Subject: Nuclear Energy Institute Comments on Draft Regulatory Guide DG-1242, "Service Level I, II, and III Protective Coatings Applied to Nuclear Power Plants," (*Federal Register* of March 11, 2010, 75FR11574)

**Industry Comments on Draft Regulatory Guide DG-1242,
"Service Level I, II, and III Protective Coatings Applied To Nuclear Power Plants."**

Figure 1. ASTM Standards Relevant to NNP Class I, II, and III Protective Coatings

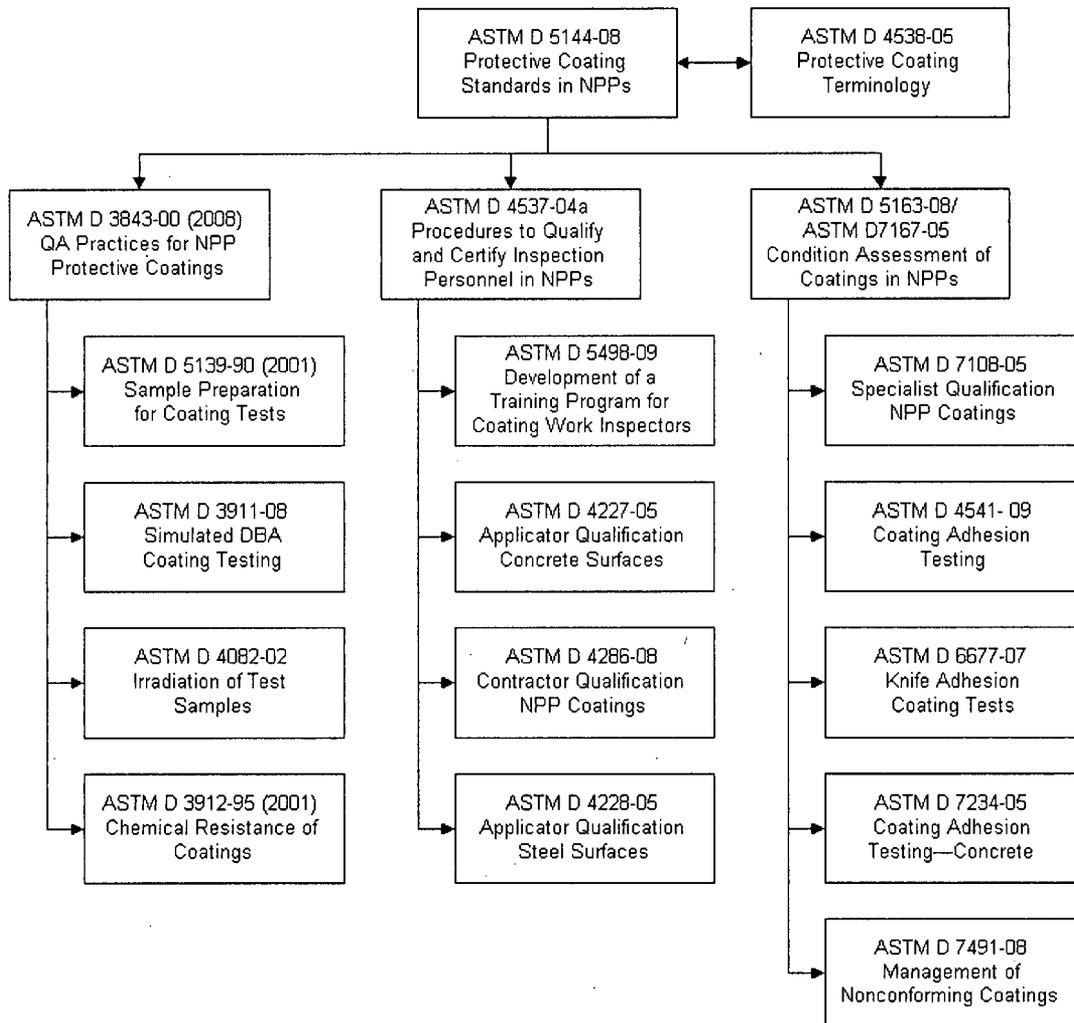
The following issues with ASTM International (ASTM) standards potentially impact Figure 1:

1. ASTM D3912-01 is used as a coating screening/qualification standard, not as a field coating assessment standard or tool.
2. ASTM D7108-05 is used as to qualify nuclear coating specialist for the coating program and coating assessment, not coating inspections.
3. ASTM D7491-08 is part of the coating condition assessment program.
4. ASTM D3911-03 has been revised to D3911-08.

Usage of ASTM D3912-95 (Reapproved 2001) is not consistent with Figure 1, which uses ASTM D3912-01.

Figure 1, ASTM Standards Relevant to NPP Class I, II, III Protective Coatings (Page 4):

Most ASTMs on this table are the same as the previous R.G. 1.54 Rev. 1. However, four were added and two were deleted. It is understood that ASTM D5962-96 was withdrawn with no replacement. Why was ASTM D 3359 (latest revision for this standard is ASTM D 3359-09) removed from the figure? Is this method of measuring adhesion not acceptable or is it covered under one of the new standards added?

Recommend incorporating all of these issues into Figure 1, which results in the following:
